**Architectural Design Review Board**  
**May 2, 2023 @ 4:00 p.m.**  
Council Chambers  
First Floor, 345 High Street  
Hamilton, Ohio 45011

**To:** Architectural Design Review Board  
**From:** Dani Baxter  
**Subject:** **Old Business - AGENDA ITEM #1**  
**136 N 3<sup>rd</sup> St – New privacy fence and roof structure installation**  
Steven Gebhart, Applicant  
Meeting Date: May 2, 2023  
Received Application: March 13, 2023  
**Impacts:** Central Area Building Inventory

**To:** Architectural Design Review Board  
**From:** Dani Baxter  
**Subject:** New Business - AGENDA ITEM #1  
810 Dayton St – Roof replacement and chimney/roof hatch removal  
Joshua Maggard, Applicant  
Meeting Date: May 2, 2023  
Received Application: April 18, 2023  
**Impacts:** Dayton-Campbell Historic District

Exhibit C – Site Plan & Photos

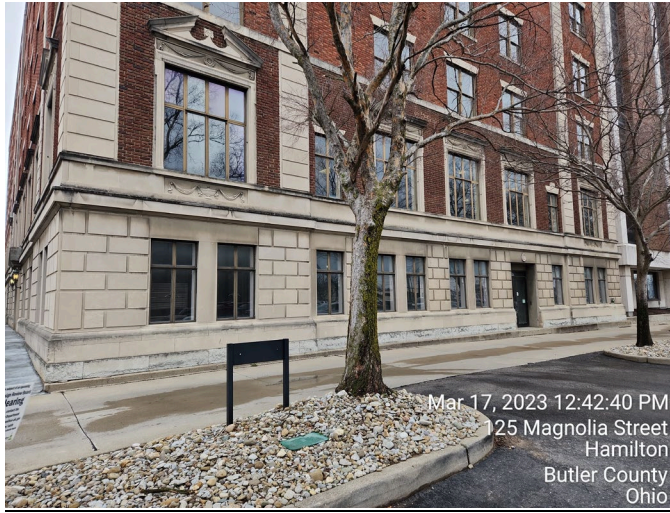
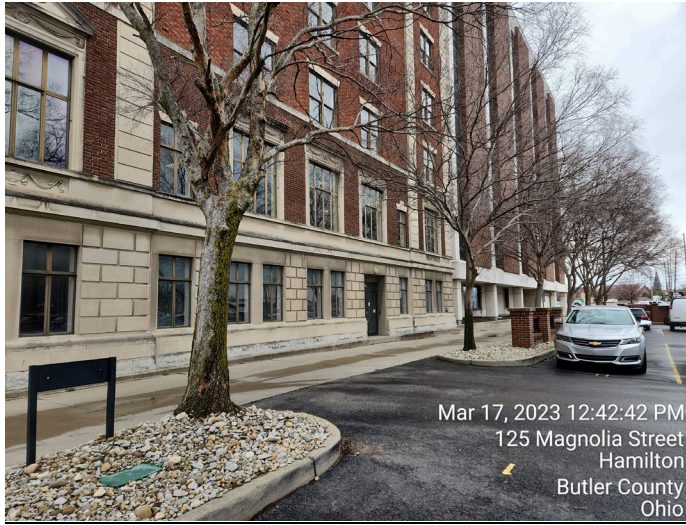
- Bark Hamilton also requires approval from Planning Commission and City Council for a Specific Use in a Business Planned Development Zone District. Bark Hamilton is set to be heard at the April 6, 2023 Planning Commission hearing.
- Magnolia Alley was vacated by Planning Commission on July 15, 2021 and ordinance number 2021-11-98.
- HVAC louvered panel vent requires a new opening in the building façade and is located between the two adjoining buildings, is setback from the alleyway, and cannot be seen from the street.

EXISTING/DEMO WEST ELEVATION  
SCALE 3/16" = 1'-0"

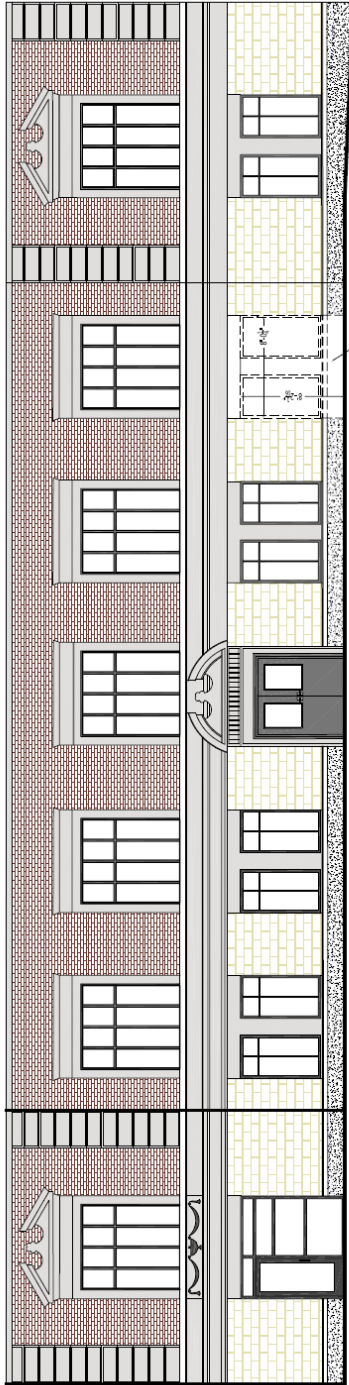
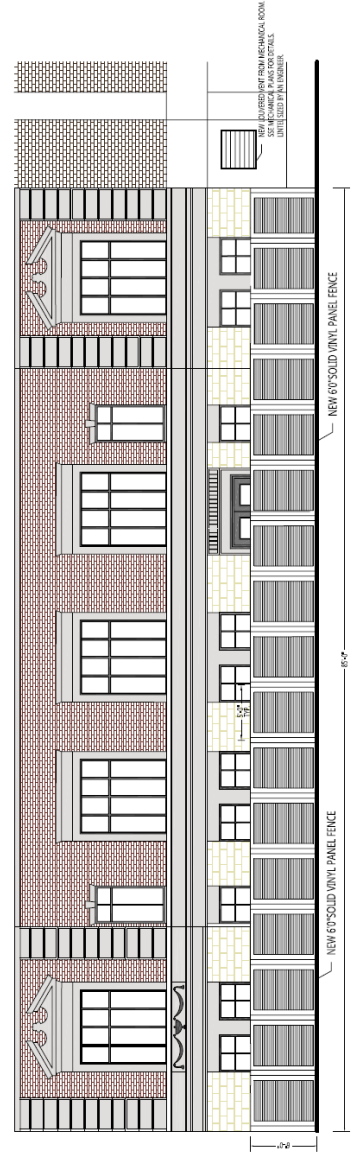
Applicant is proposing a six-foot tall gray, steel panel fence with four, seven-foot tall brick masonry columns, one located at each corner of the fence. The proposed brick columns will match the existing columns in the parking lot. The fence manufacturer and style information provided by the applicant is for Best Vinyl Fence & Deck, out of Utah. However, the applicant is proposing to use a comparable product produced locally.

- Planning Department staff think a tan vinyl fence, matching the stone color along the first floor, would create a uniform appearance than the proposed white vinyl.

- ADRB move to approve the COA request to install 6-foot tall gray steel privacy fence, brick columns, and possible detached roof structure as proposed after determining it maintains compliance with Section 2600 of the Hamilton Zoning Ordinance and ADRB Policies & Guidelines.
- ADRB move to deny the COA request as proposed, as it is not compliant with Section 2600 of the Hamilton Zoning Ordinance and/or ADRB Policies & Guidelines.
